Product News

Solar/185 / Stellar/170 / Luna 200 kg

INTRODUCING THE NEW SOLAR WITH 185 KG LIFTING CAPACITY

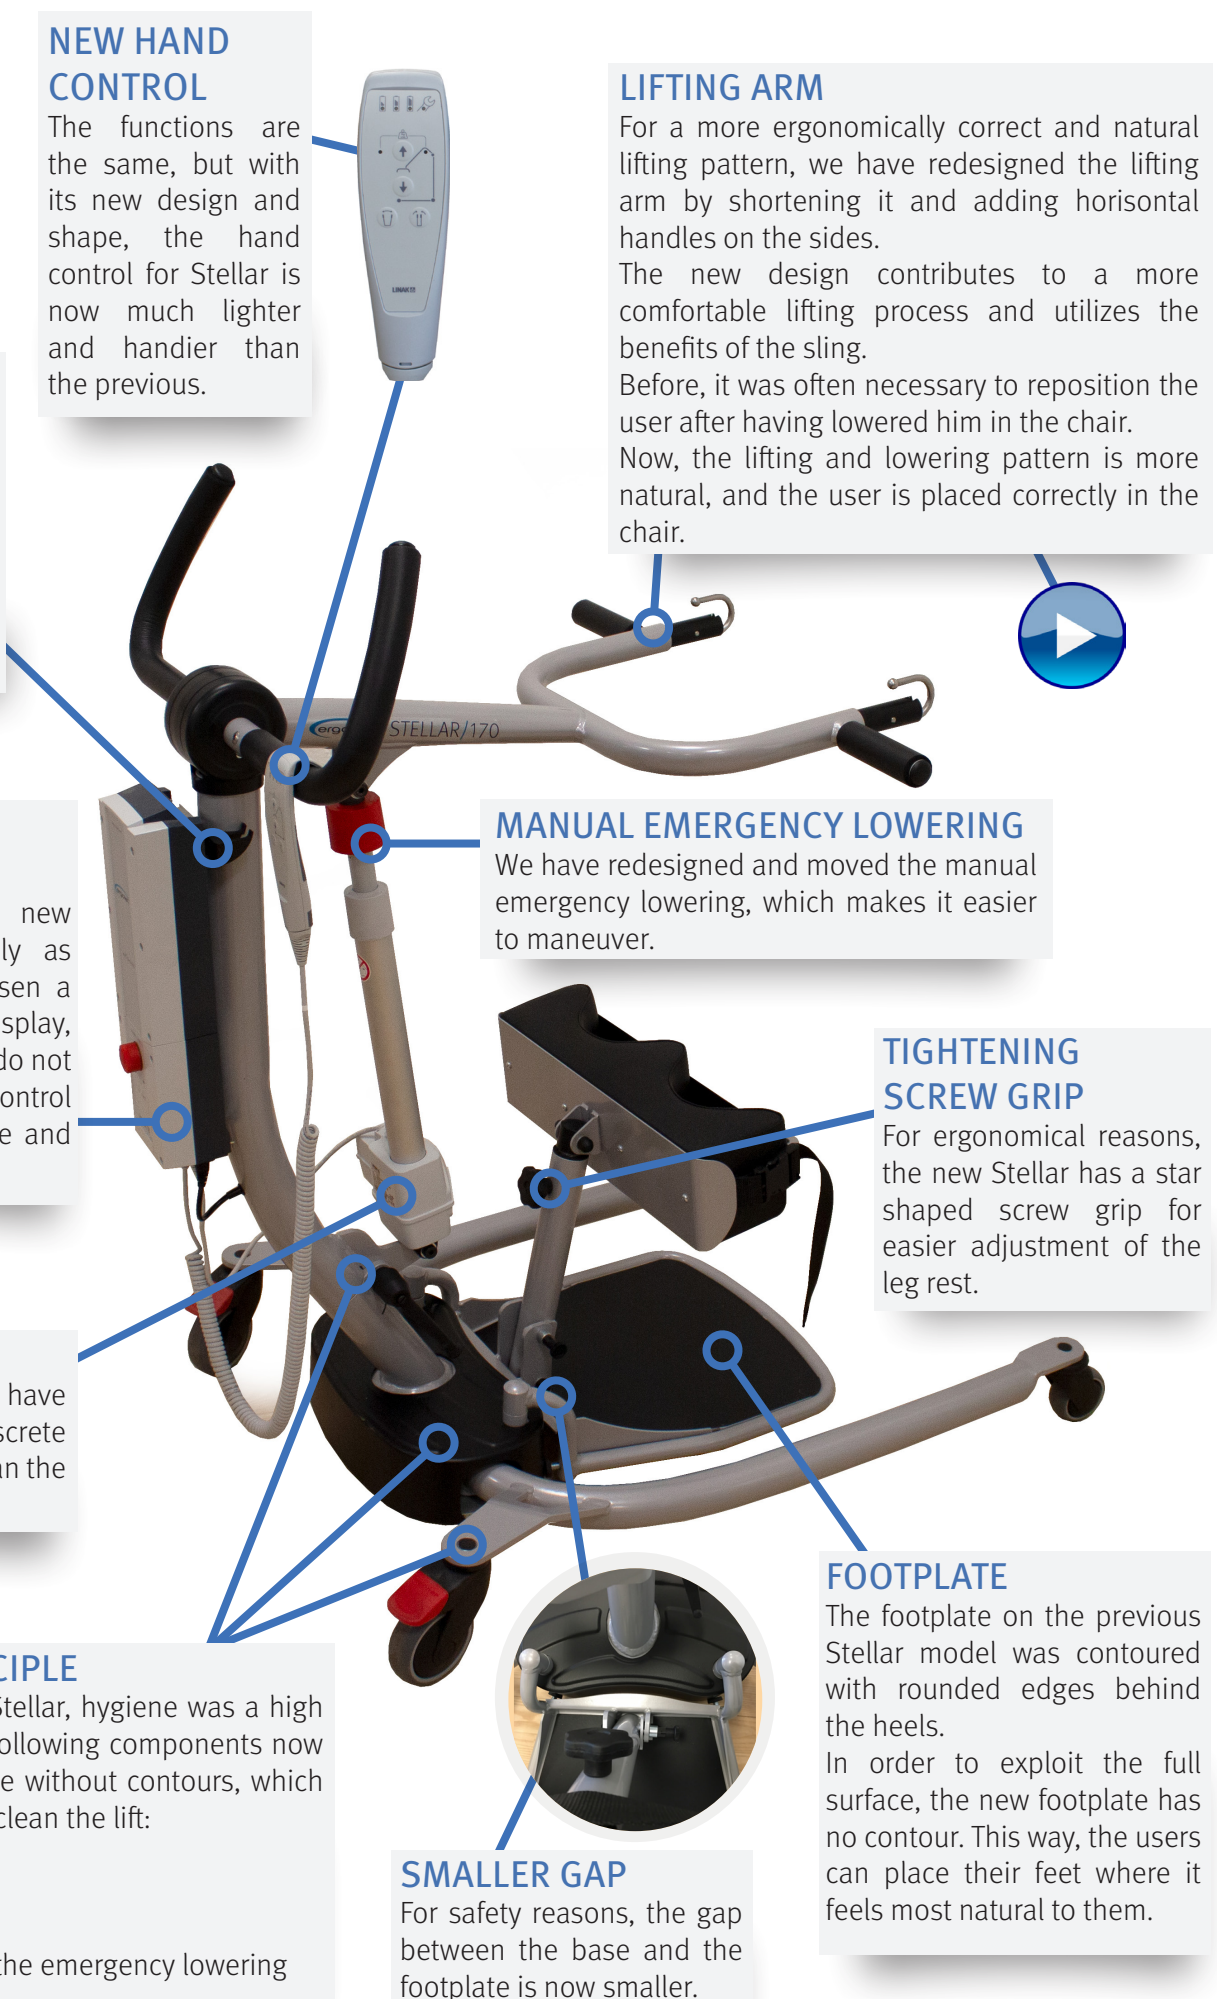
For safety reasons, the gap between the base and the footplate is now smaller.

The footplate on the previous Stellar model was contoured with rounded edges behind the heels.

In order to exploit the full surface, the new footplate has no contour. This way, the users can place their feet where it feels most natural to them.

LUNA CEILING LIFT (1 channel, 200 kg)

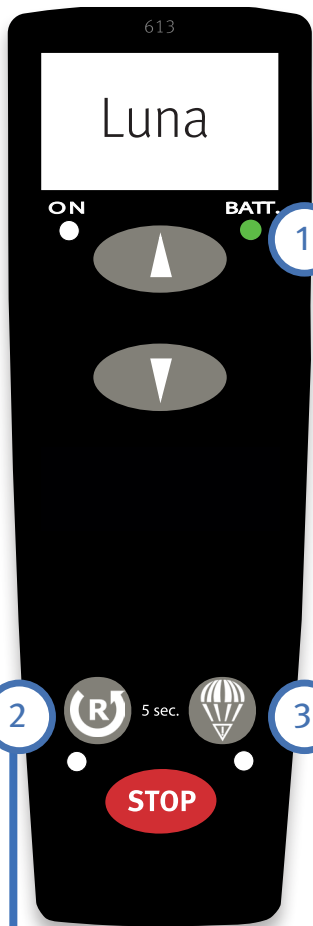
The hand control (BATT.) now only indicates charging for two minutes. Hereafter it will be turned off for the rest of the charging session.

Everytime a hand control is connected, Luna will automatically be in emergency mode.

The emergency lowering button on the side foil now works, even if the hand control is not connected.

4. PRINTED CIRCUIT BOARD

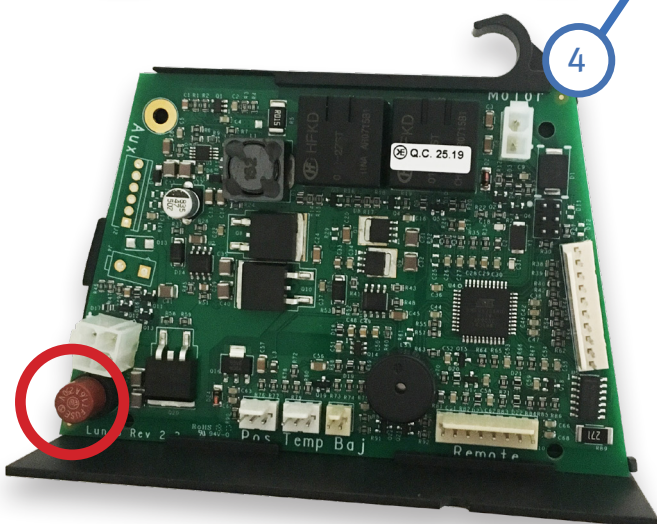
As with most other electrical devices, it sometimes happens that the Luna hand control shortens, due to mishandling of the cord. In order to avoid having to change the entire printed circuit board (PCB), we have added a fuse (see red circle), which is the only thing you need to change if the hand control shortens. The sparepart list has been updated.

Because of the new PCB slide, the PCB can now be inserted and removed without any use of tools, which adds it to the Luna "5-minutes-maintenance" list.

PATENTED SLING HOOKS

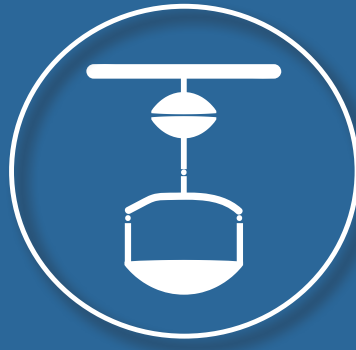
- 1: Place the strap in the hook.
- 2: Pull the strap down and the sling hook is locked with a “click”.

Pull upwards to unlock the sling hook and the strap can be removed.
